## Addendum Submission

For the part retrospective retention of completed lakes Bridges and Puma, the retention and completion of part completed raised reservoirs Lakes 1, 2 and 3 (all for angling purposes) along with the clubhouse and detailed landscaping scheme at  
Monk Lakes, Staplehurst Road, Marden, Maidstone, TN12 9BS

0183/01  
Addendum Submission – Monk Lakes

III Proposed Club House and Car Park Layout 0183 04 04

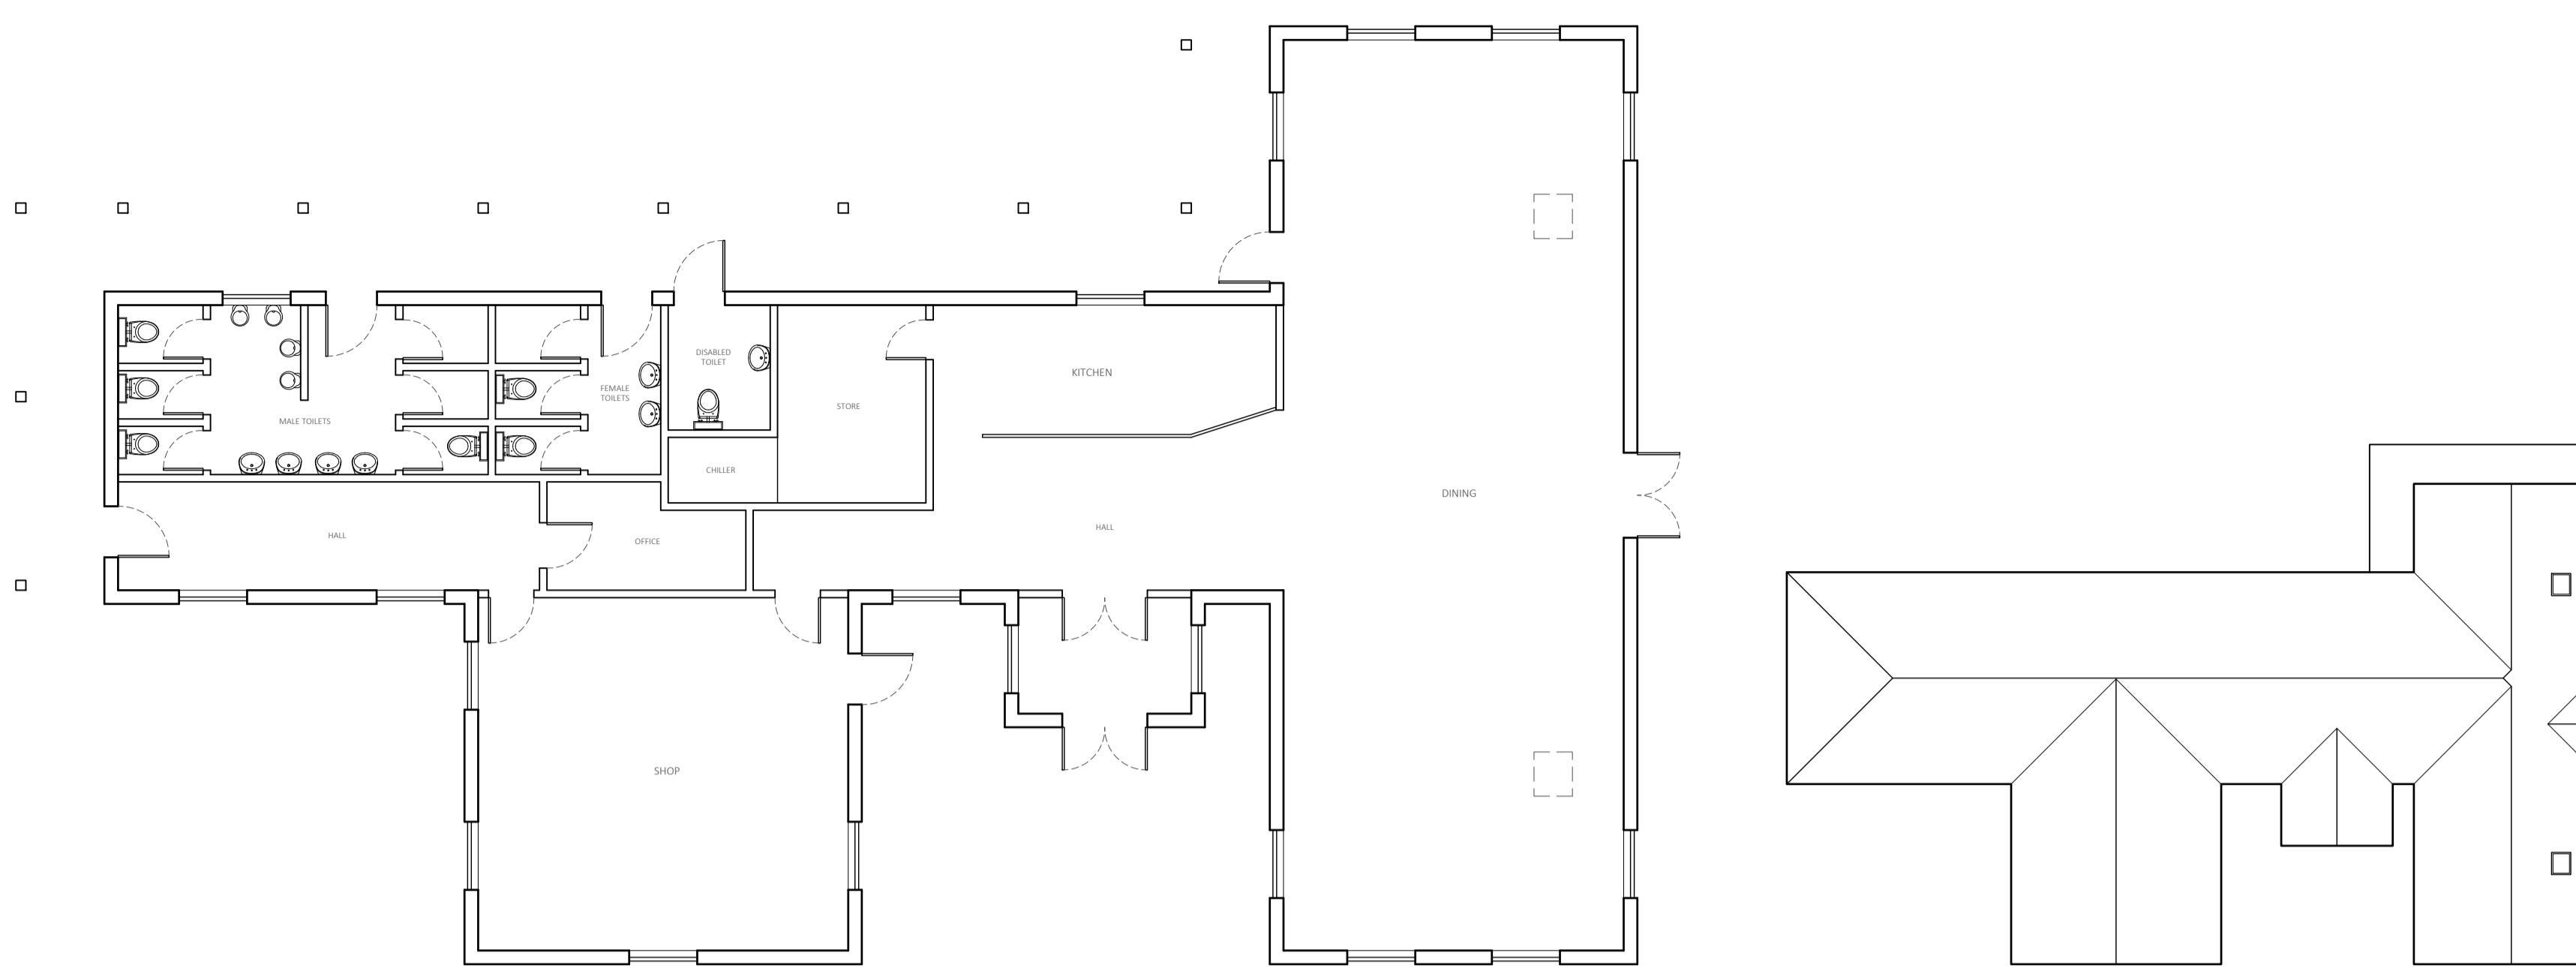
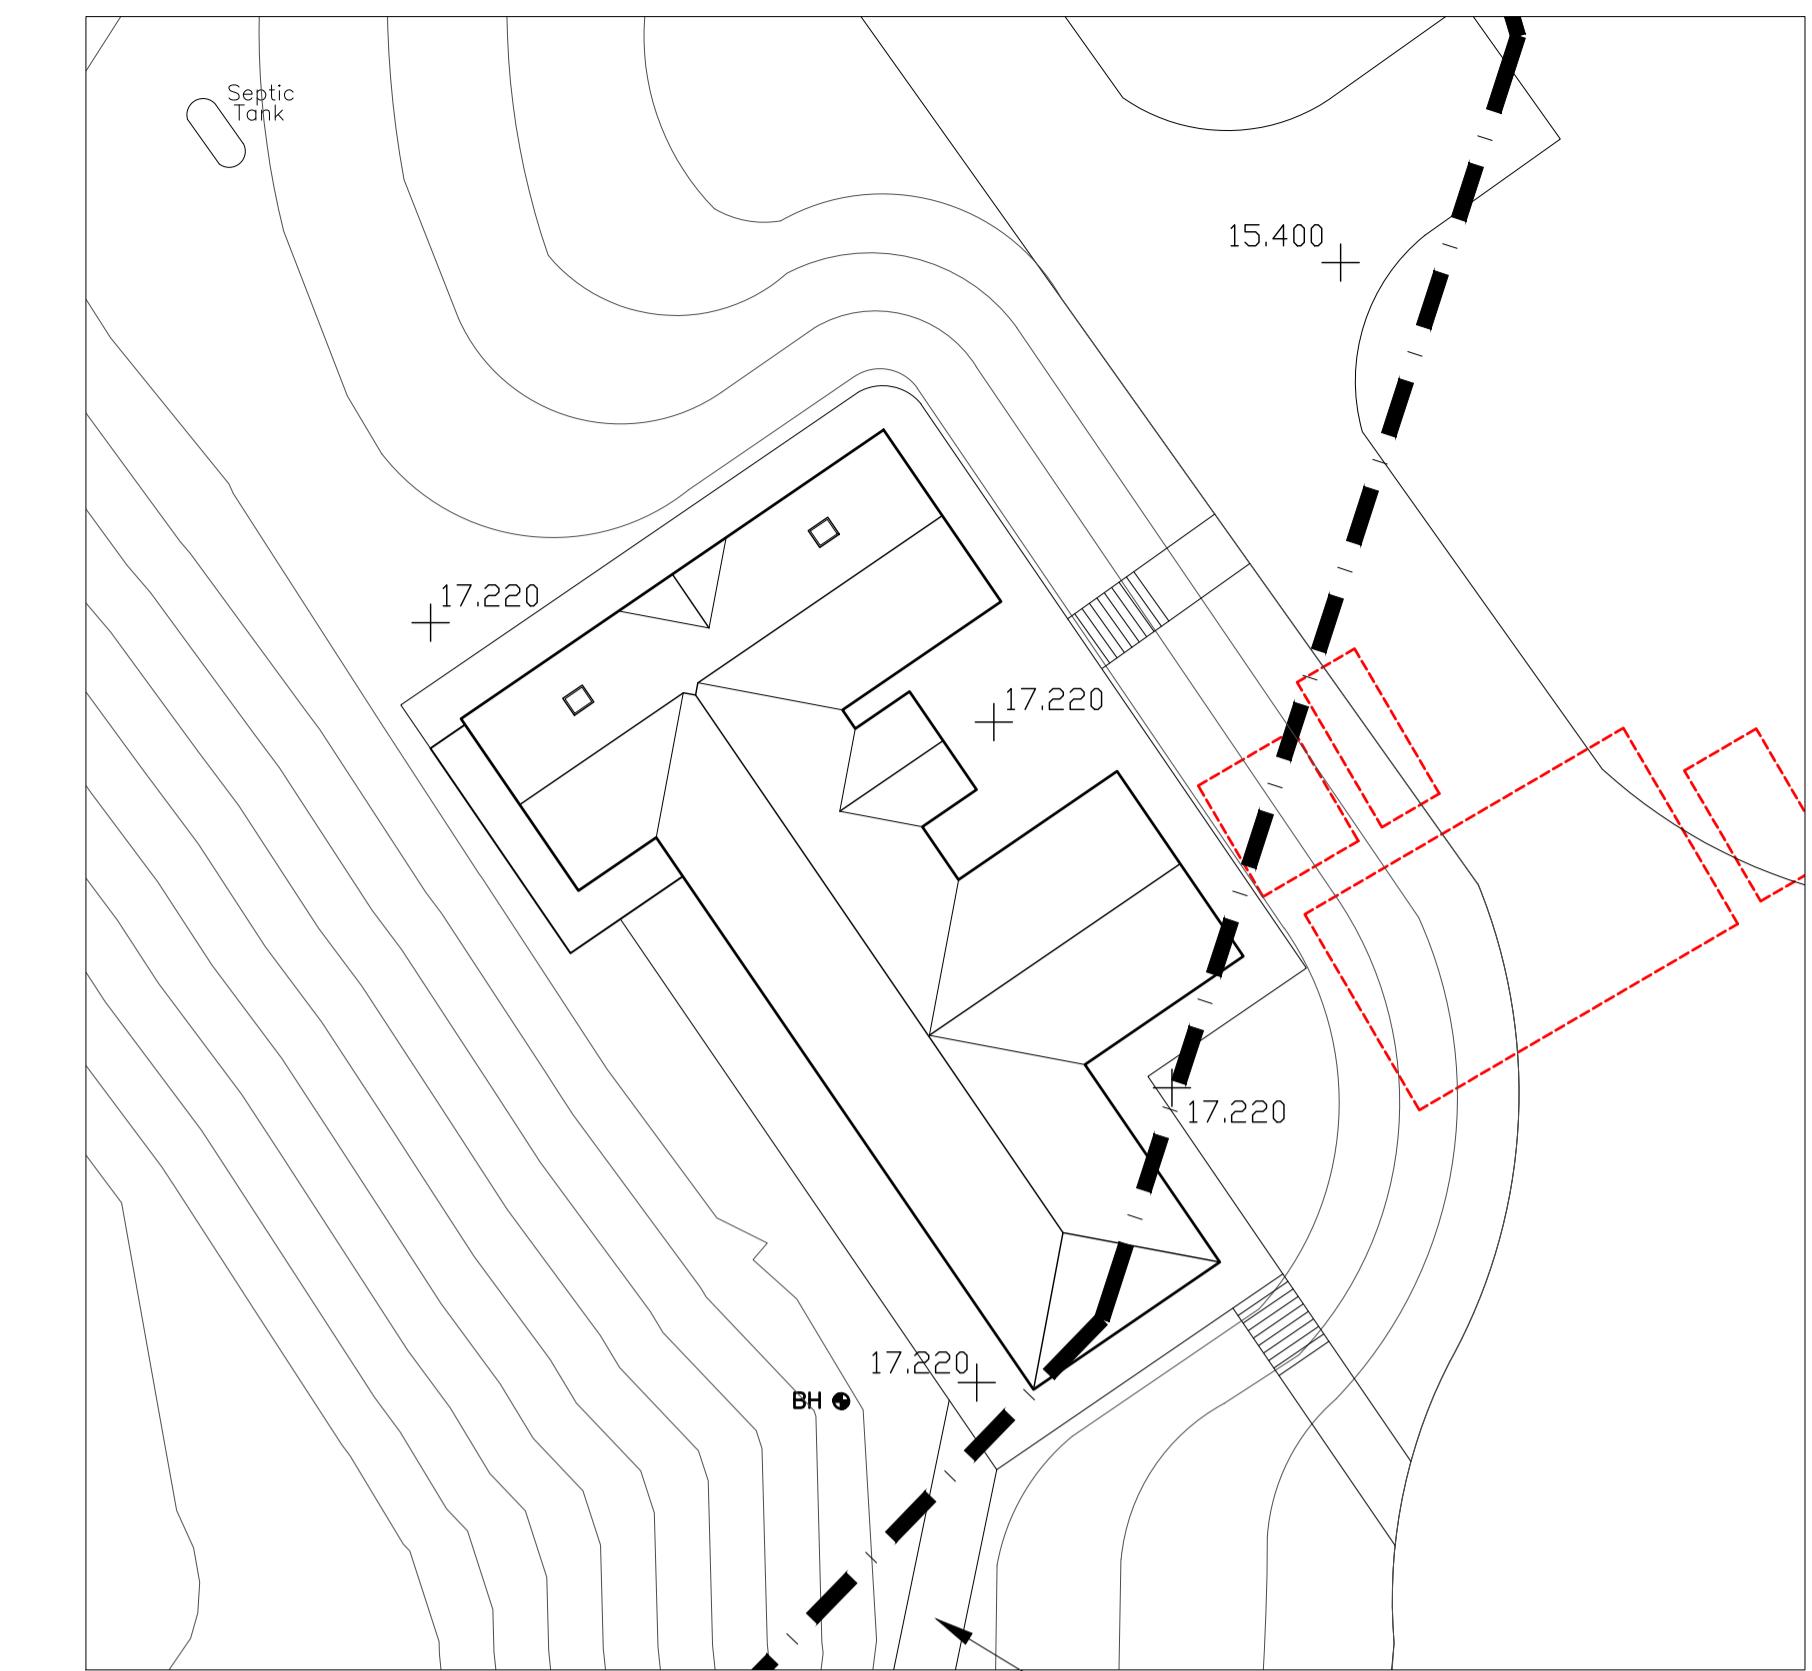
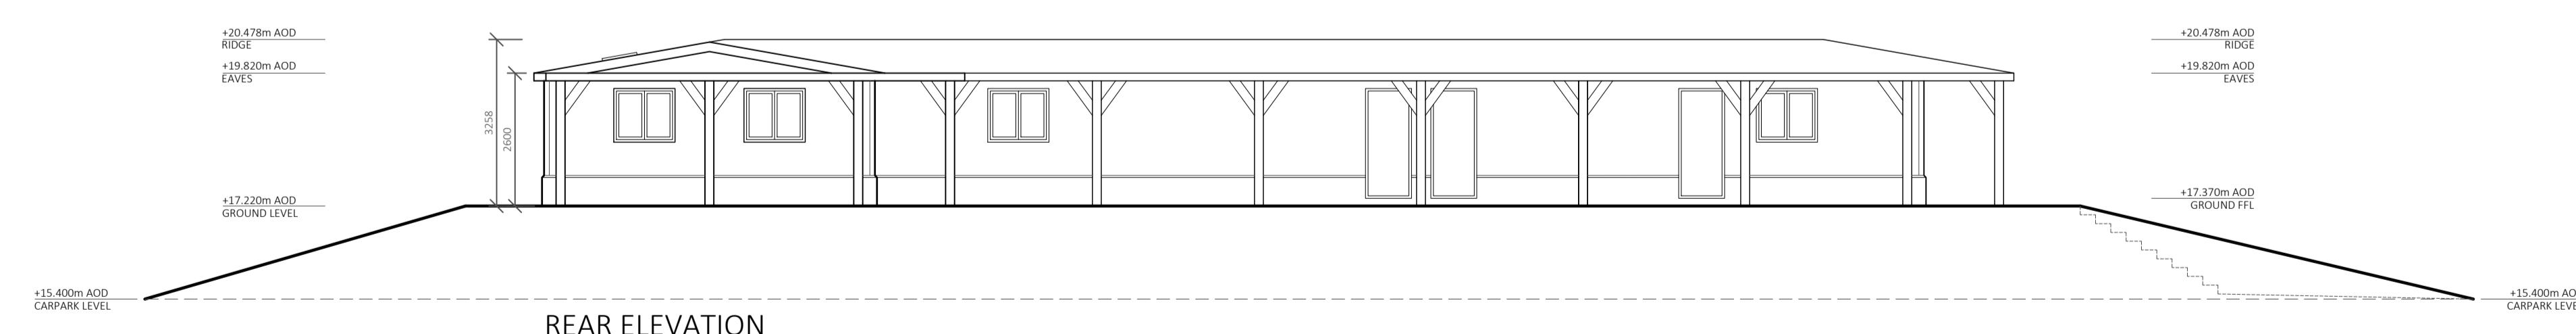
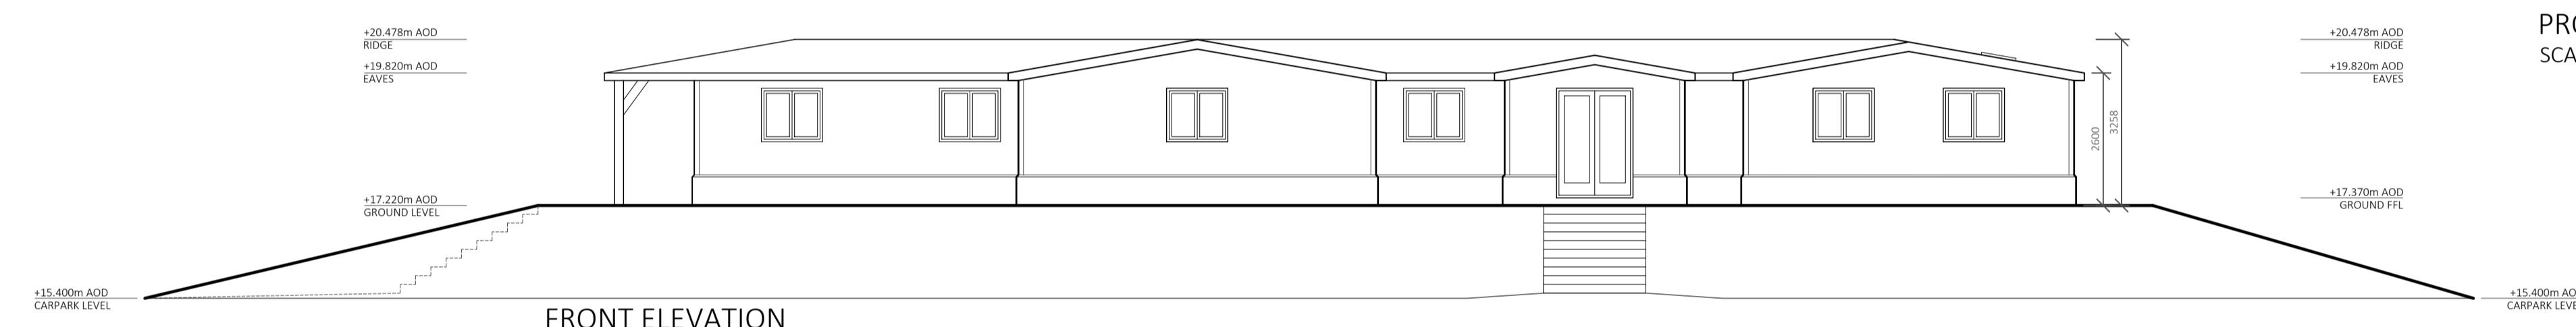
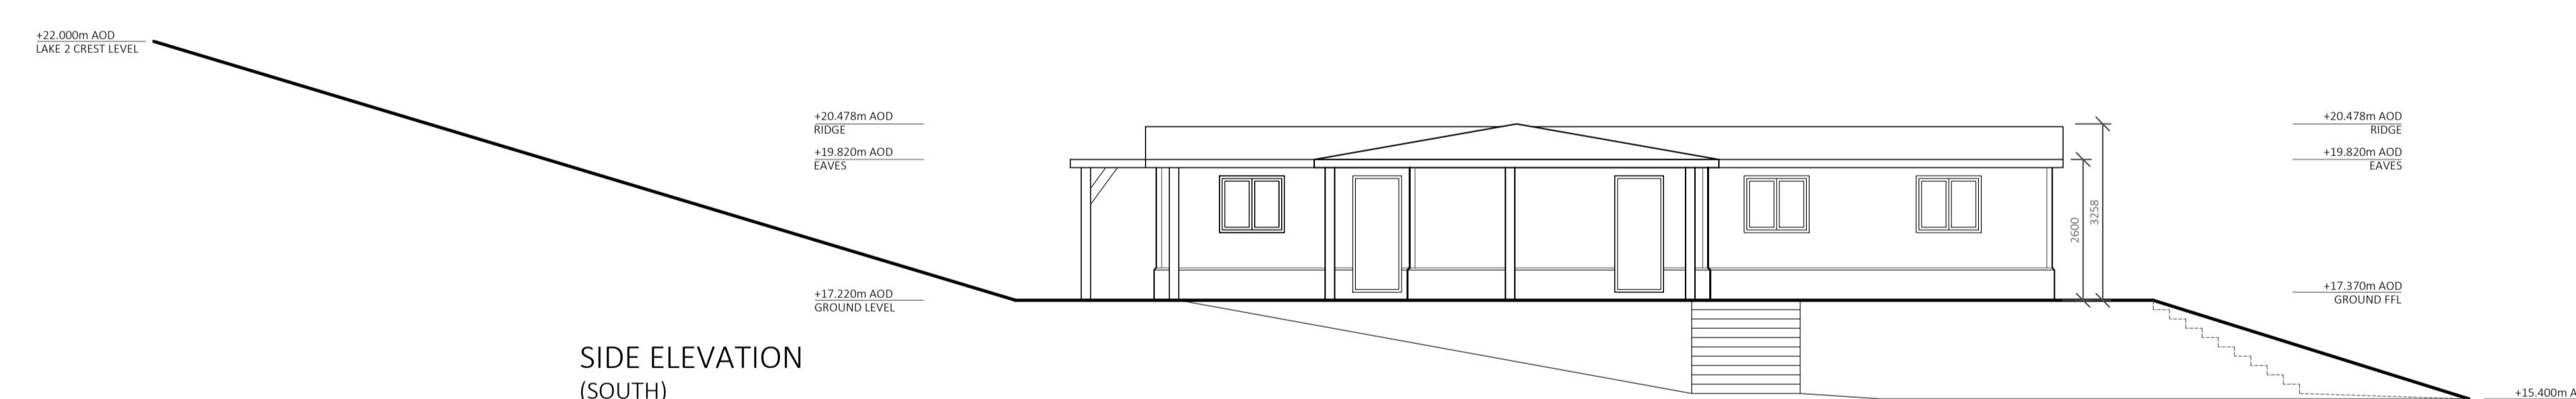
1.5 As part of the works undertaken to satisfy the Environment Agency and remove the holding objection, it has been agreed to raise the land surrounding the clubhouse building by nearly two metres for flood risk mitigation; the increase in land levels have been accounted for in the accompanying clubhouse carpark layout plan together with updated floor plans and elevations in relation to the clubhouse building itself. Given the increase in land levels it was considered reasonable and appropriate to reduce the ridge height associated with the clubhouse building floor plans and elevations so as to mitigate for any landscape impact created by an increase in the height afforded to the massing of the clubhouse itself on the wider area. It is considered that the mitigation proposed in the significant reduction of the ridge height of the clubhouse building has sufficiently addressed any issues in this regard.

CLUBHOUSE POSITION AND ORIENTATION, CARPARK LEVELS AMENDED	RL	04/10/19
	DESCRIPTION:	BY:	DATE:
